Product Change Notification / CENO-26WFQV556

CCB 5170 and 5170.001 Final Notice: Qualification of MTAI as a new assembly site for selected A3P0xx, A3PN0xx, AGL0xxxx and AGLN0xxxx device families available in 68L VQFN (8x8x1mm) and 48L VQFN (6x6x1mm) packages.

CCB 5170 and 5170.001
Pre and Post Change Summary
PCN #: CENO-26WFQV556

LEAD FRAME COMPARISON – VQFN 68L

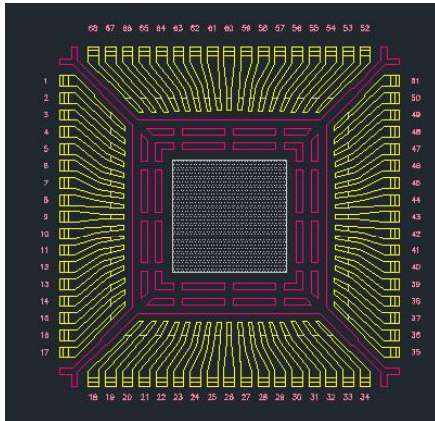
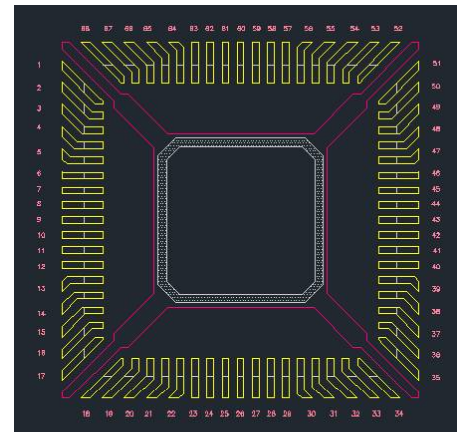
Lead frame DAP surface prep	Ag Ring Plating
Lead Plating	Matte tin
Lead-Frame Paddle Size	125x125 mils

Lead frame DAP surface prep	Ag Ring Plating
Lead Plating	Matte tin
Lead-Frame Paddle Size	122x122 mils

LEAD FRAME COMPARISON – VQFN 48L

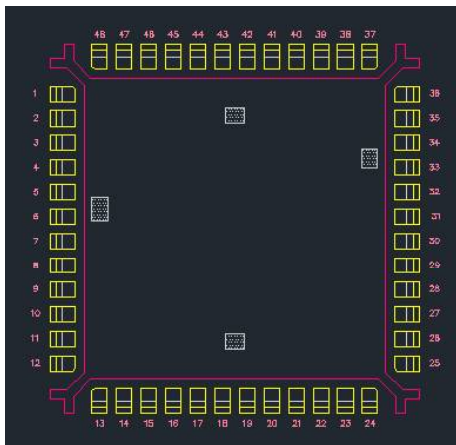
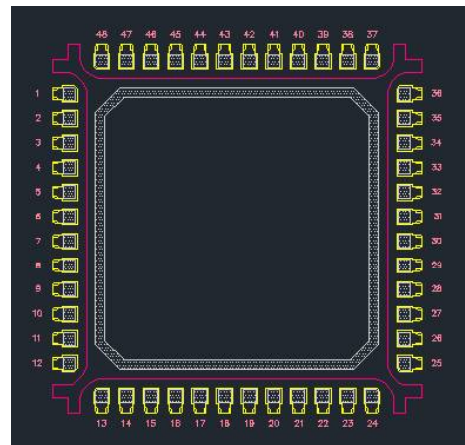
Lead frame DAP surface prep	Ag Ring Plating
Lead Plating	Matte tin
Lead-Frame Paddle Size	193x193 mils

Lead frame DAP surface prep	Ag Ring Plating
Lead Plating	Matte tin
Lead-Frame Paddle Size	193 x 193 mils
